ADDENDUM

Addendum#: 2
Project: Coffman Park – Pickleball Courts
Date: 09.08.2020
Bids Due: 09.11.2020

THE CITY OF DUBLIN
COFFMAN PARK - PICKLE BALL COURTS

DETAILS

C-503

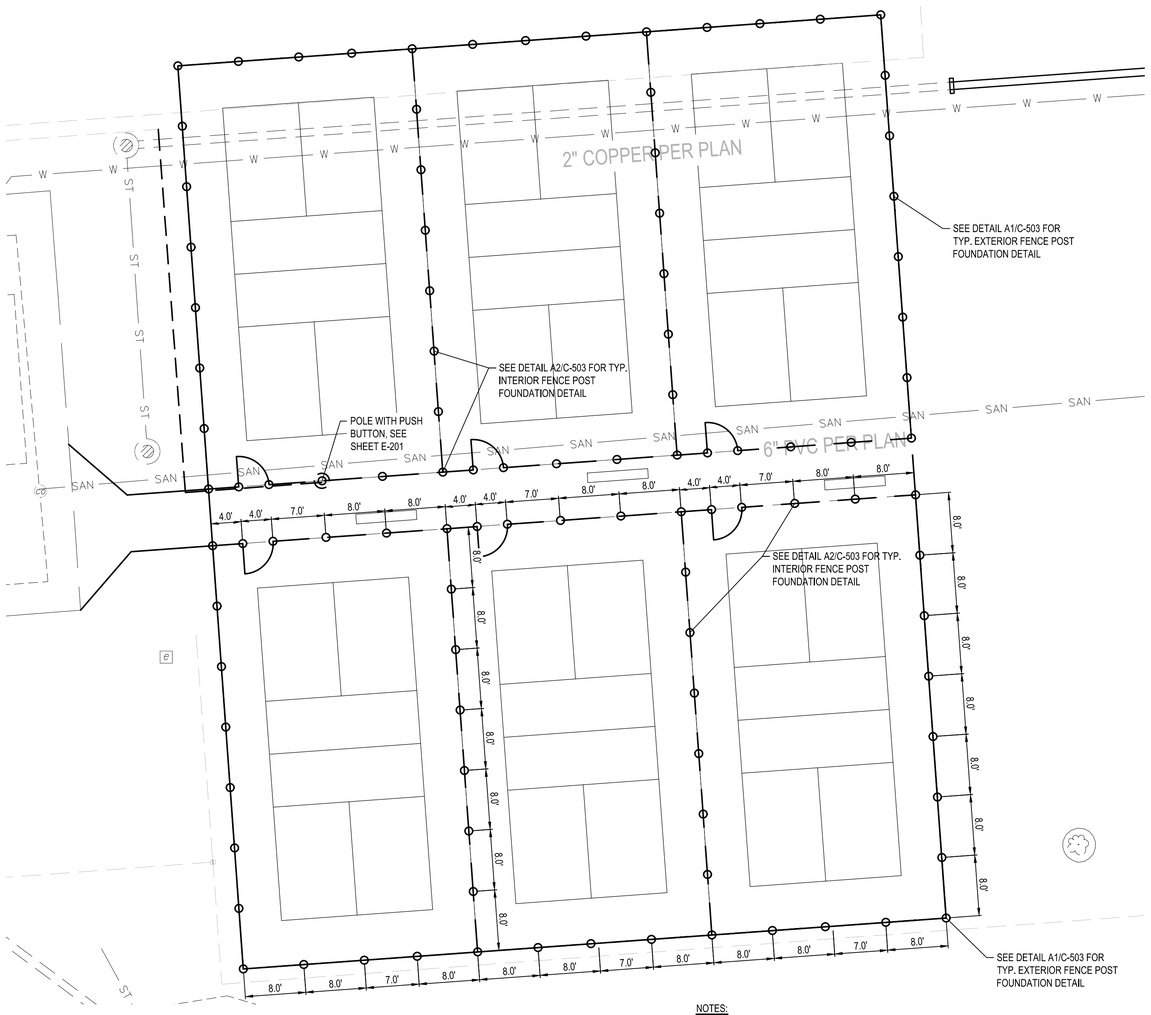
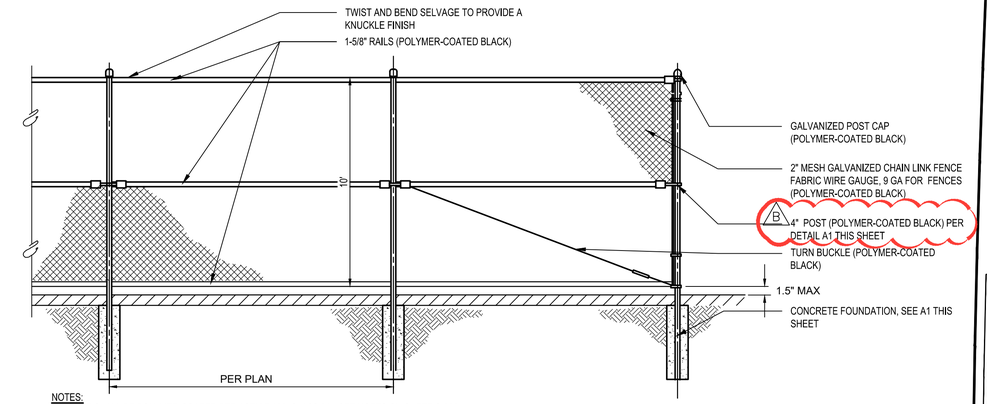
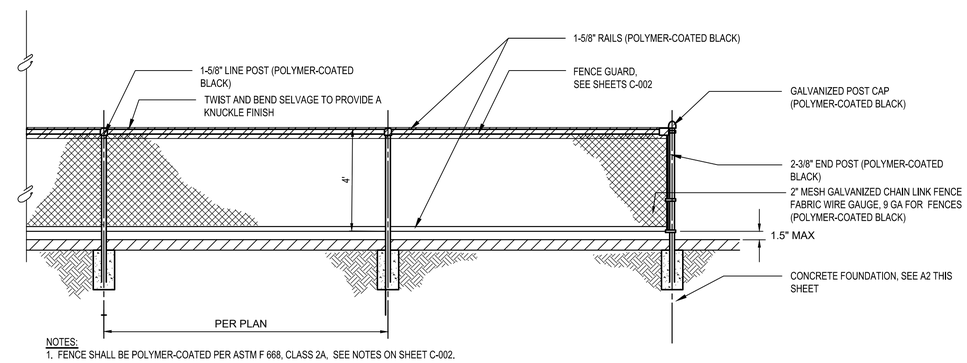
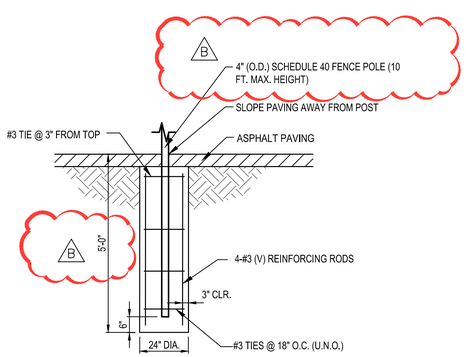
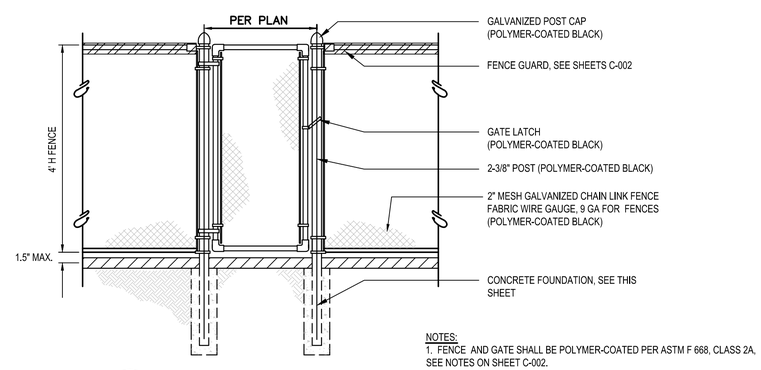
1. Sheet TS-001 – Title Sheet
    a. Alternate Bid table has been updated to match the Bid Sheet in Section 2 – Page 2-2.
2. Sheet C-503 – DETAILS
    a. Indicates a 5" diameter posts for 10'-0" fence sections, 4" diameter posts maybe utilized in lieu of the 5" posts.
    b. Fence post foundation was also reduced some due to the post diameter reduction.
3. Stormwater Structure Specification/Clarifications:
    a. Pre-formed flexible joint sealants per ASTM-990 may be utilized in lieu of "O-Ring" joints per ASTM C-443 for square structures.
    b. Connections to structure are not required to be booted per plan, but are required to be sealed water-tight.
